SHOREHAM NUCLEAR POWER STATION

NRC-608

SHOREHAM NUCLEAR POWER STATION - UNIT I
Docket No. 50-322

ATTACHMENT A

Fig. 3.1 HYDROGEN GAS PRODUCTION RATE BY RADIOLYSIS DUE TO VARIOUS FISSION PRODUCT SOURCES

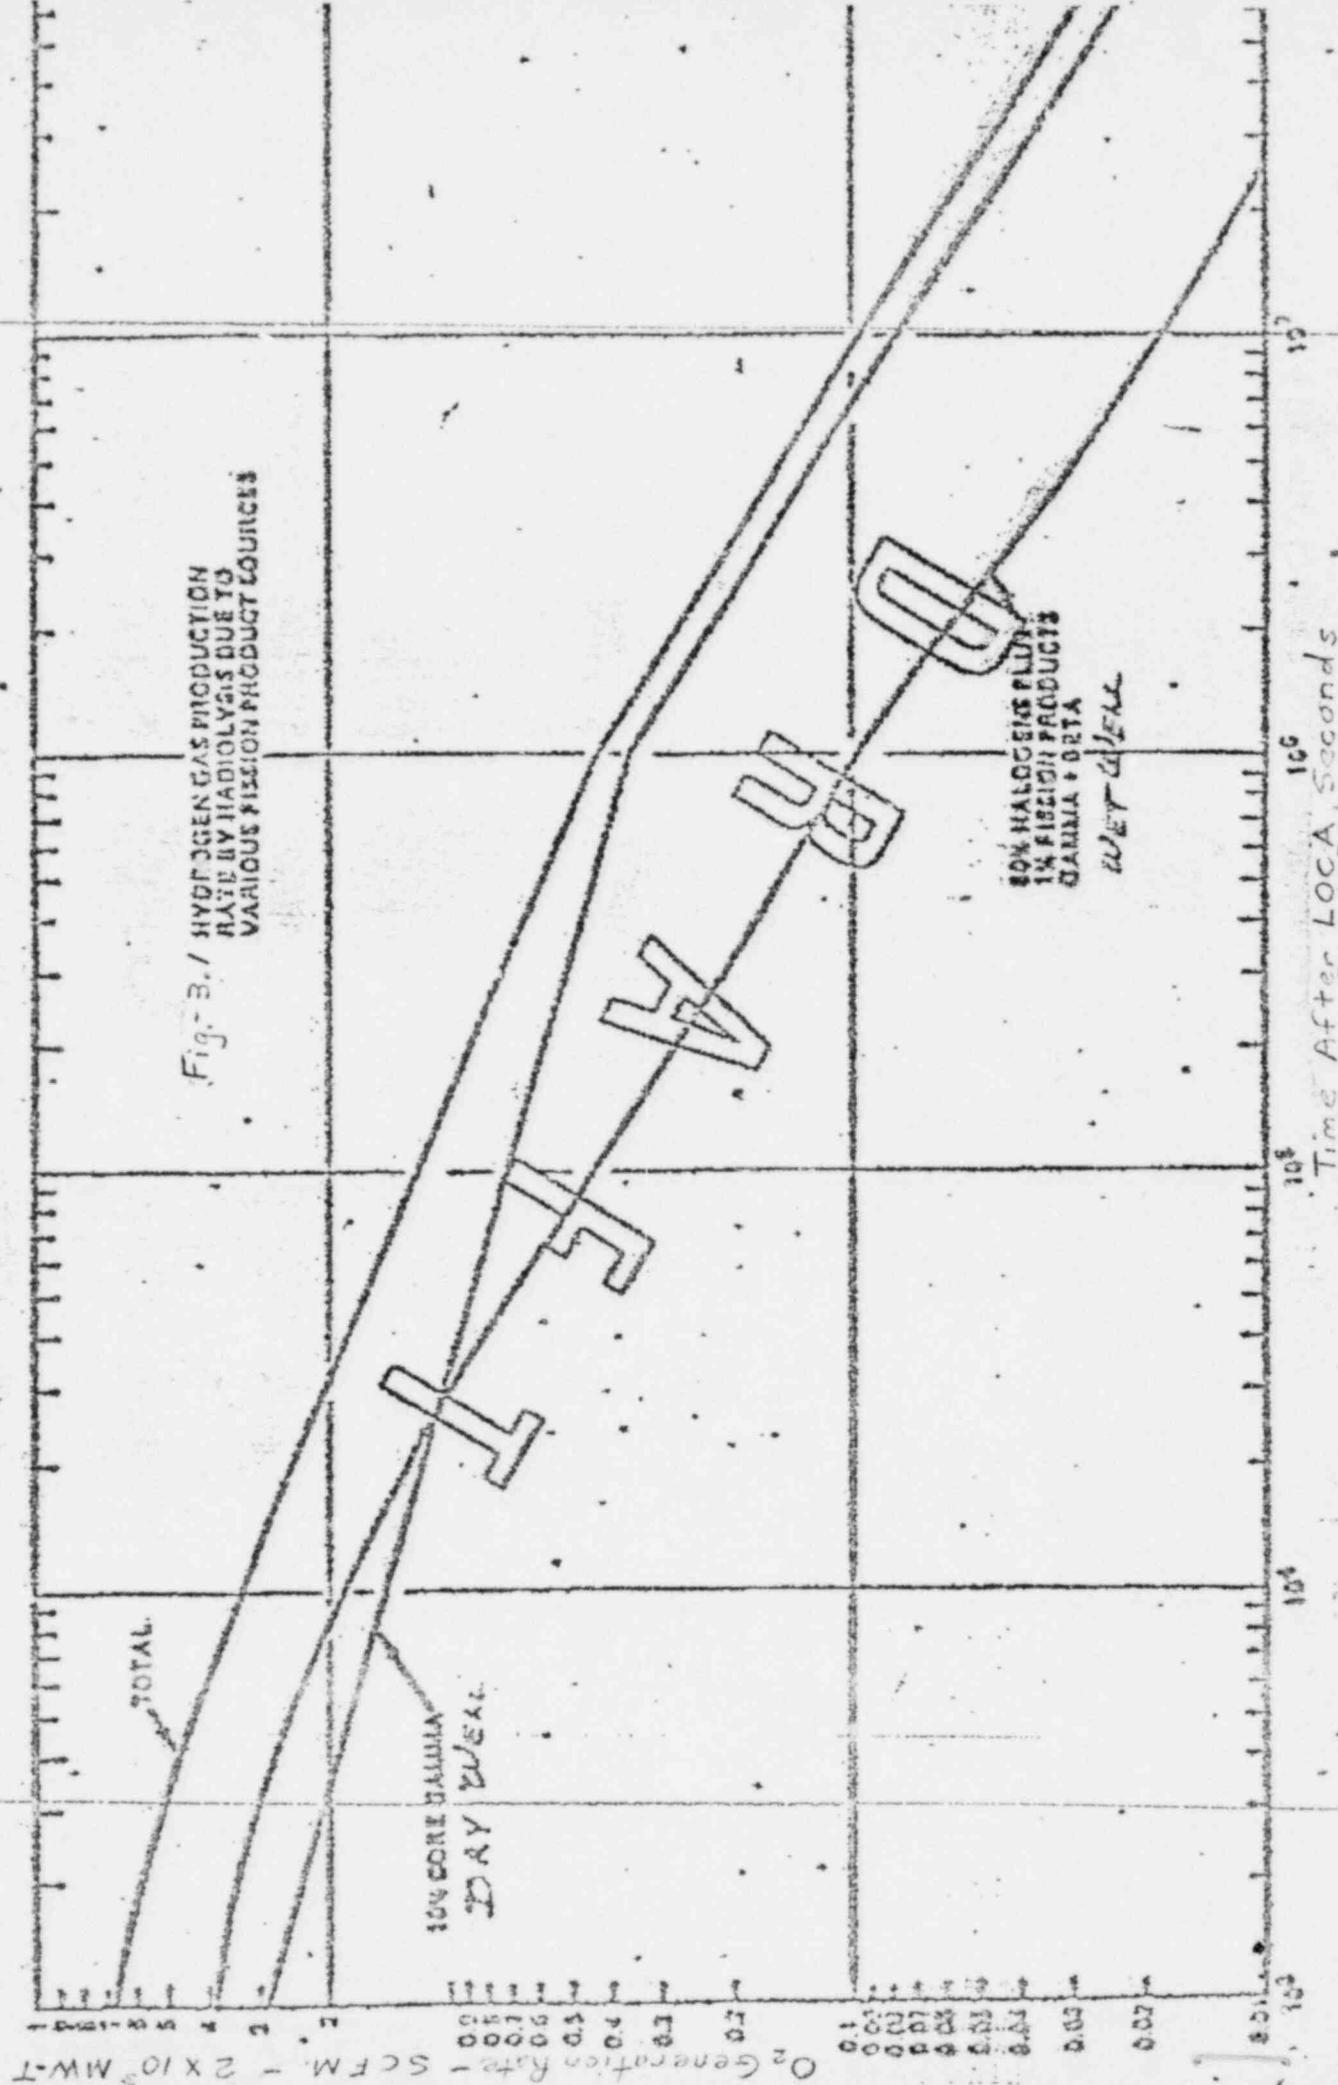
1. The hydrogen recombiners will function with an inerted containment.
2. The recombiners will recombine 3 SCFM of oxygen with 6 SCFM of hydrogen.
3. Generation of oxygen results only from the radiolytic decomposition of water. The rate varies with temperature and location (drywell, wetwell).

The quantities (rates) are determined from Fig. 3.1 (attached) of Draft 4 of proposed standard ANSI-N-275, ANS 56.1 June 1976, "Containment Hydrogen Control".
